Class 2 Permit Modification Request

Addition of a Shielded Container

**Waste Isolation Pilot Plant
Carlsbad, New Mexico**

WIPP Permit Number NM4890139088-TSDF

Figure 1
Shielded Container

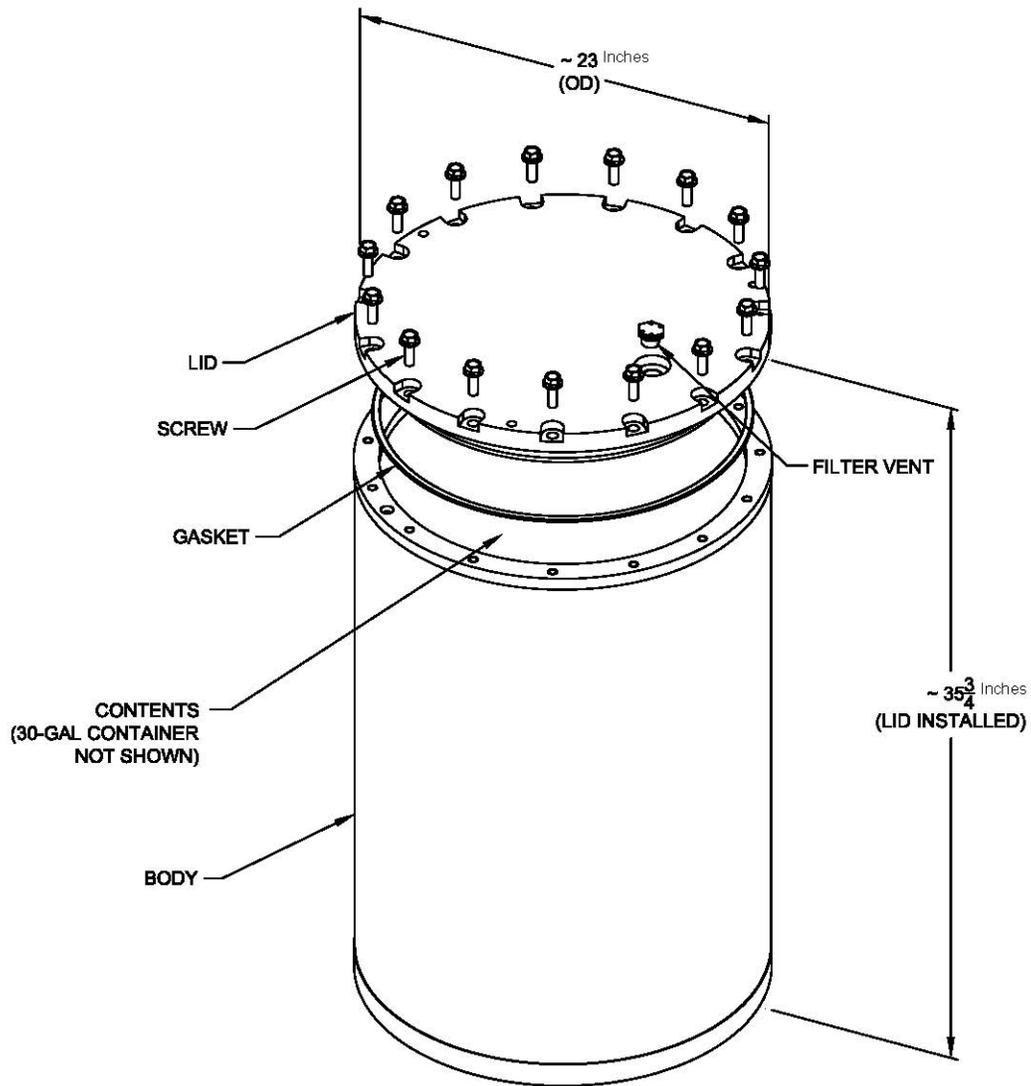
The shielded container is designed to hold an inner 30-gallon container. The cylindrical sidewall of the shielded container has approximately a 1-inch-thick lead shield sandwiched between a double-walled carbon steel shell as shown in Figure 1. The external wall is approximately 1/8-inch thick, and the internal wall has a thickness of approximately 3/16-inch. The lid and the bottom of the shielded container are made of carbon steel and are approximately 3 inches thick. The empty weight of the shielded container is approximately 1,726 pounds. The shielded container and the inner 30-gallon container will be vented.

Figure 2
3-Pack Assembly of Shielded Containers with Axial and Radial Dunnage

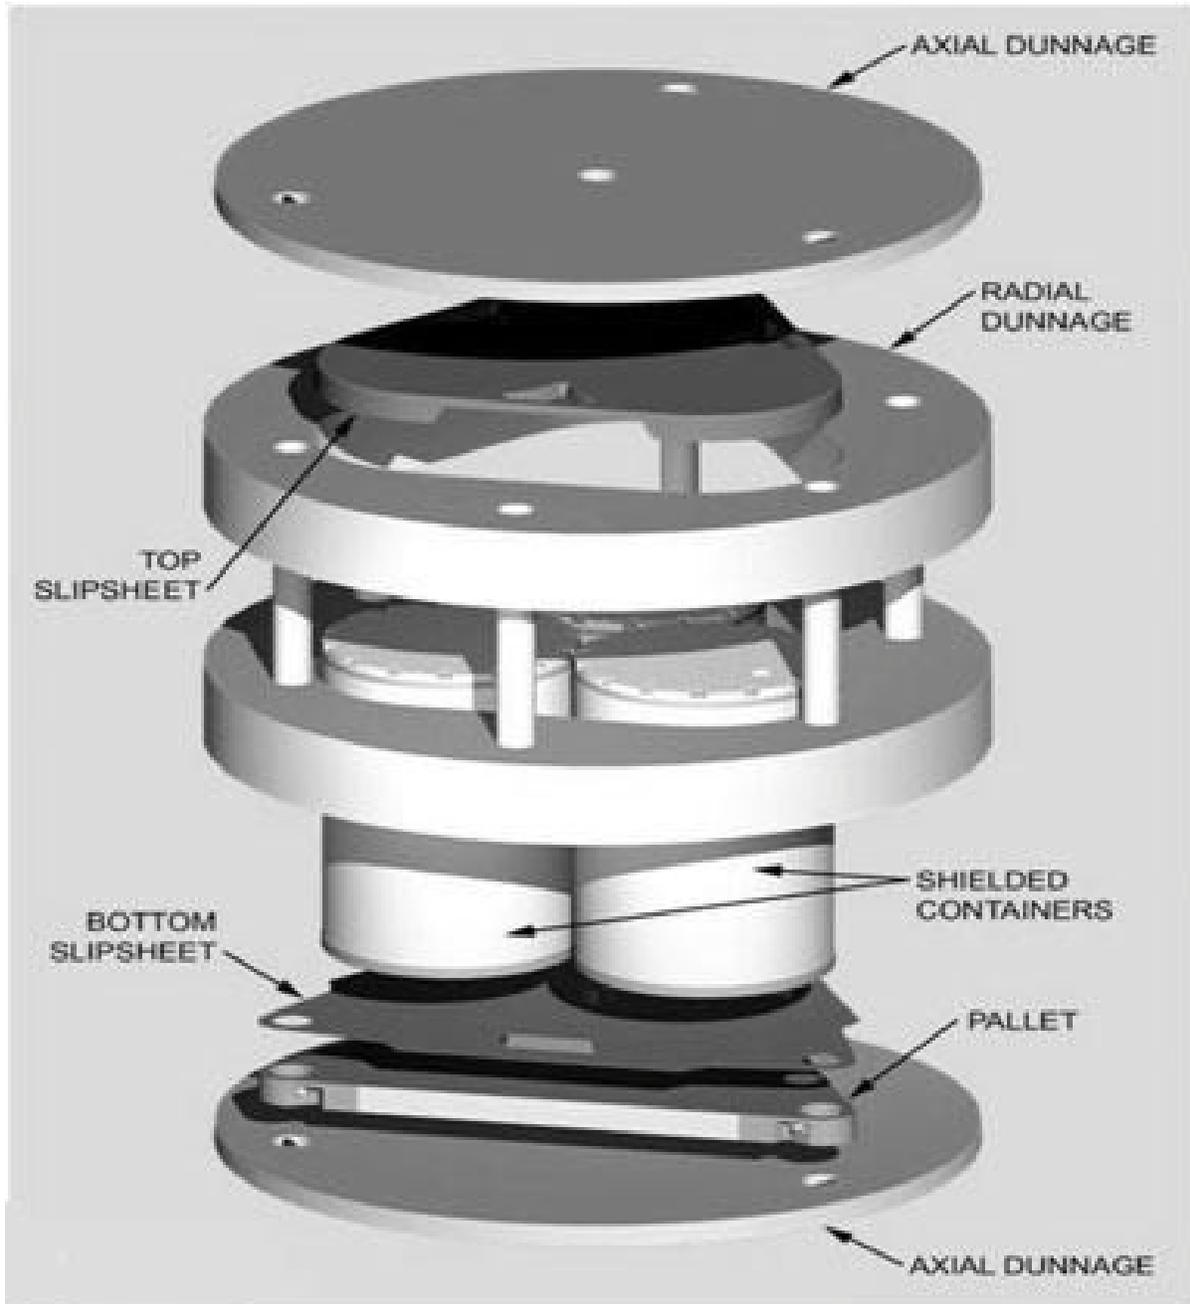
The shielded containers will be assembled in a 3-pack configuration on a triangular pallet surrounded by radial and axial dunnage components. They will be transported as a single 3-pack configuration within the existing HalfPACT packaging. The 3-pack configuration will remain intact throughout transportation and emplacement (Figure 2).

Figure A1-37
Typical Shielded Container

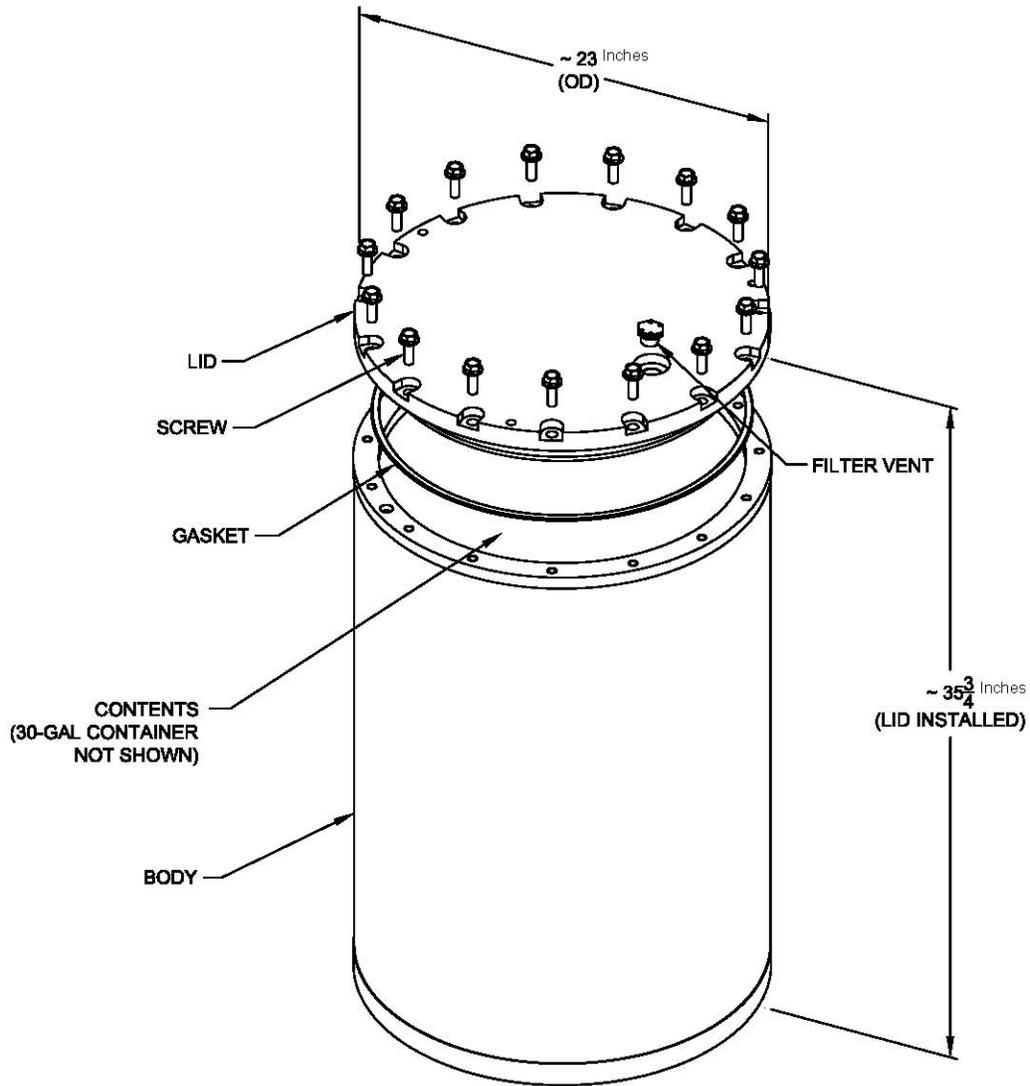
The shielded container meets the requirements for DOT specification 7A (Figure A1-37).

Shielded containers having a 30-gallon inner container which has a gross internal volume of 4.0 ft³ (0.11 m³). One or more filter vents will be installed in the shielded container lid to prevent the escape of radioactive particulates and to prevent internal pressurization. This container will be used to emplace RH TRU mixed waste, but the shielding will allow it to be managed as CH TRU mixed waste.
